Preliminary Development Plan Climate Controlled Facility

Application #PL2021-063

April 22, 2021

Project Information and Site Plan

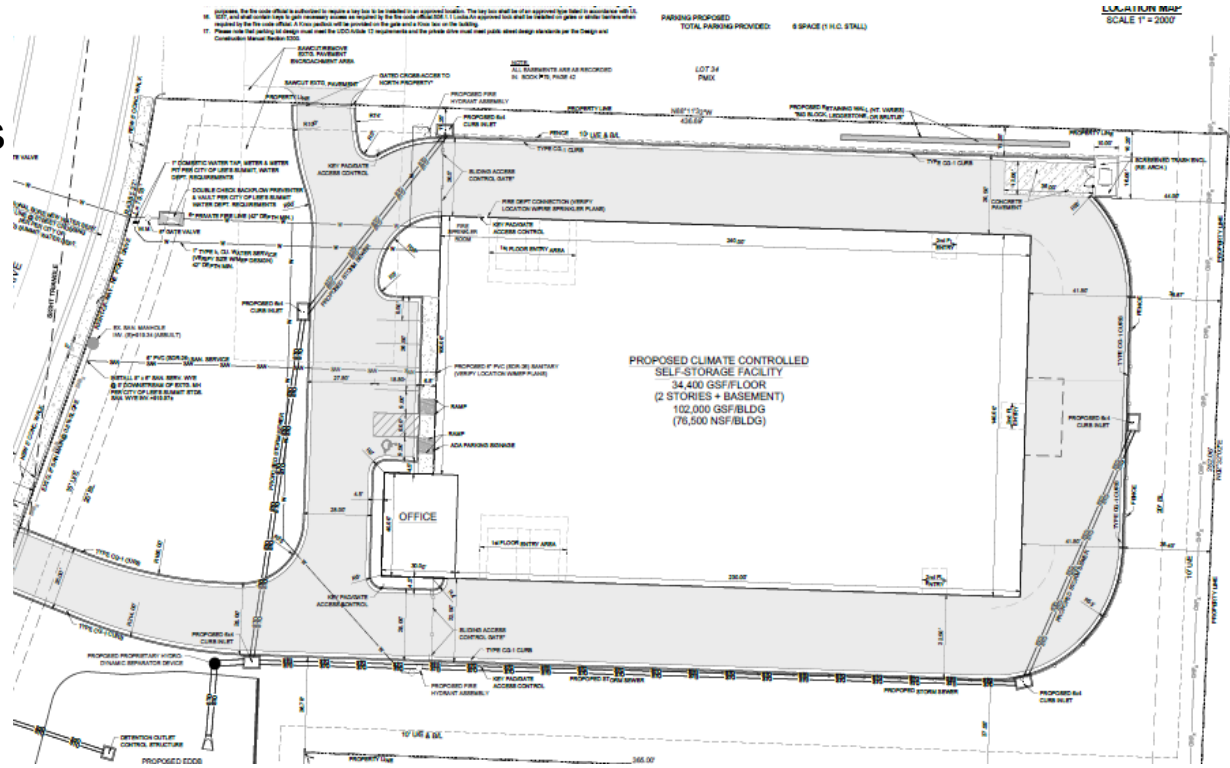
Modification Request #1 is for the Exterior Accessed Units.

- Required - All activities are required to be carried on inside the structure when associated with an indoor climate controlled facility.
- Proposed - The applicant proposes approximately 17 exterior access storage units.
- Recommended - Staff supports the modification. The design of the building allows for outdoor activities to only be permitted within the rear and sides of the building. The topography, the design of the site, and the amount of proposed landscaping will help shield these activities from off-site.

Modification #2 is for the Roof Pitch.

- Required - The roof pitch is required to be 1:3 when associated with a mini-warehouse facility.
- Proposed - The proposed roof is a flat roof with varying parapets and other features.
- Recommended - The proposed development is not a traditional storage facility and is designed to have an office-like appearance. Staff supports the modification.

1. A modification shall be granted to allow outdoor activities (i.e. exterior access to non-climate controlled storage units) to occur on site.
2. A modification shall be granted to the 1:3 roof pitch requirements to allow a flat roofed building.
3. The development shall be in accordance with the preliminary development plan, inclusive of the use of architectural smooth metal panels as a conditional material, as depicted on the building elevations.

WEST ELEVATION

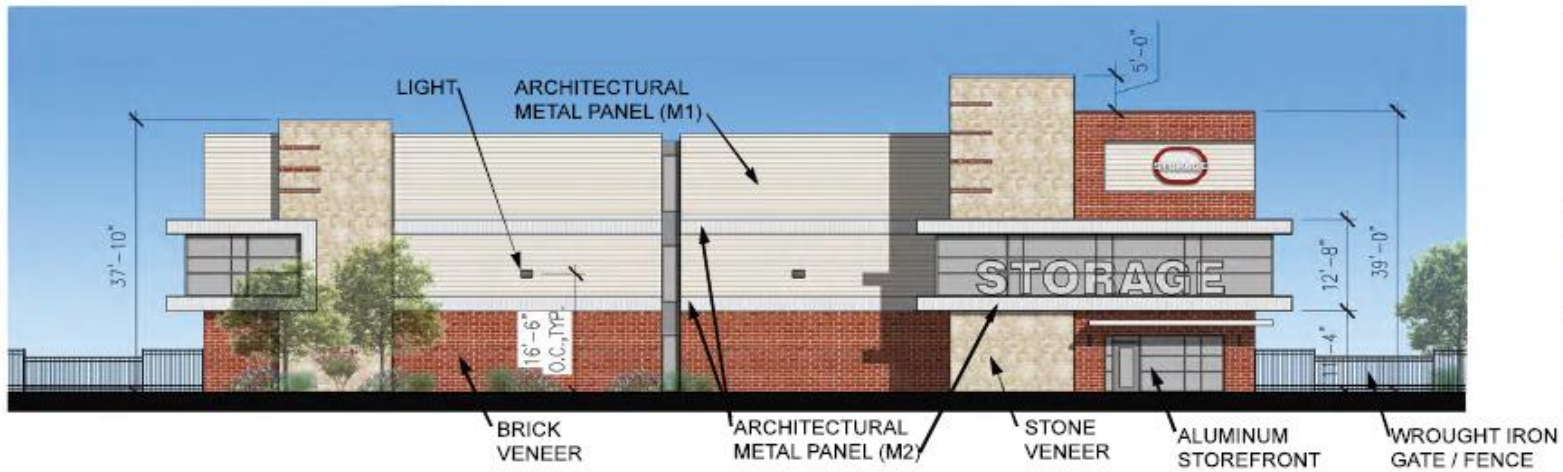
Conditional Material Proposed:

- Proposed - smooth architectural metal paneling
- Required - Masonry, concrete, stucco, and glass. Metal is to be used in an incidental role. However the material can be approved by by the Planning Commission and/or City Council.
- Recommended - Staff recommends approval of the request. The quality of metal building materials has improved over the years. It's also commonly seen in industrial, commercial and residential construction.
